April 8, 2020

Subject: Endorsement of NEI White Paper, "Changes to NEI 10-04 and NEI 13-10 Guidance for Identifying and Protecting Digital Assets Associated with Emergency Preparedness Functions," Dated March 2020

Project Number: 689

- 1) Changes to NEI 10-04 and NEI 13-10 Guidance for Identifying and Protecting Digital Assets Associated with Emergency Preparedness Functions

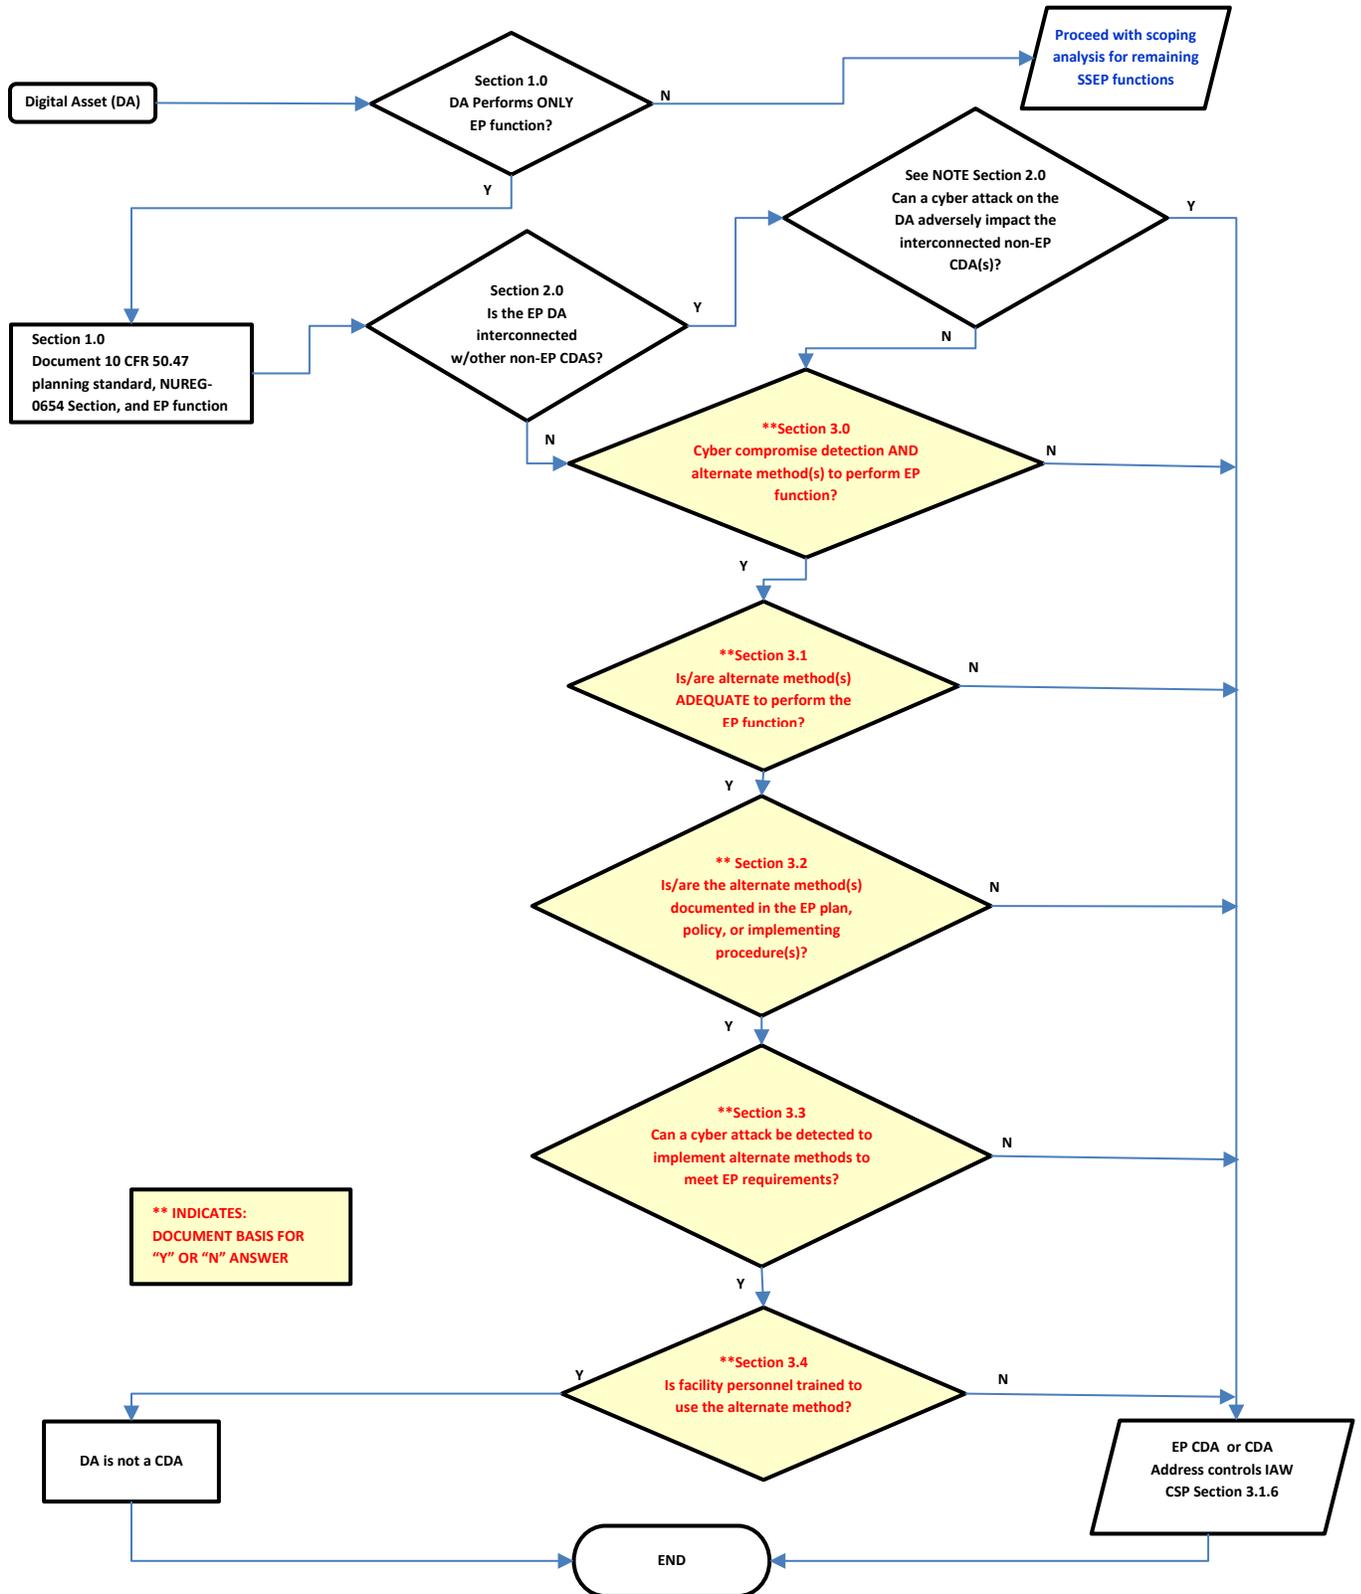
EP Scoping Criteria for Critical Digital Asset Determination:

1. Does the digital asset only perform an EP function as described in the sixteen planning standards (Section 2.3)?

- a. No; is not associated with the EP criterion, or is also relied on for safety, important-to-safety, or security functions. The asset must be screened for other functions (SSEP) in NEI 10-04.
- b. Yes; proceed to #2

2. Is the EP only digital asset interconnected with other non-EP CDAs such that the DA can be leveraged (e.g., via a cyber attack or compromise) to adversely impact the interconnected non-EP CDA (i.e., the attack vector exists and has not been mitigated through the implementation of cyber security controls implemented in accordance with CSP Section 3.1.6)? **Note:** If the EP DA provides protection that is inherited by a non-EP CDA, the EP DA must be assessed to ensure the attack vector does not exist or has been mitigated through the implementation of cyber security controls.

- a. No; proceed to #3
- b. Yes; identify DA as CDA

3. If the digital asset is compromised due to a cyber attack, can the cyber compromise of the DA be detected in time so that the EP function(s) performed by the digital asset can be fulfilled as required by the associated planning standard(s)?

- a. No; identify DA as CDA
- b. Yes; DA is not a CDA. The EP Scoping Analysis template below may be used to document the basis that supports the non-Critical classification.

For those EP CDAs that do not meet the indirect criteria, then the CDA will be a direct CDA and licensees will have to address all the security controls in accordance with their CSPs Section 3.1.6. Licensees may utilize the approved NEI 13-10 guidance for the cyber security controls assessment process.
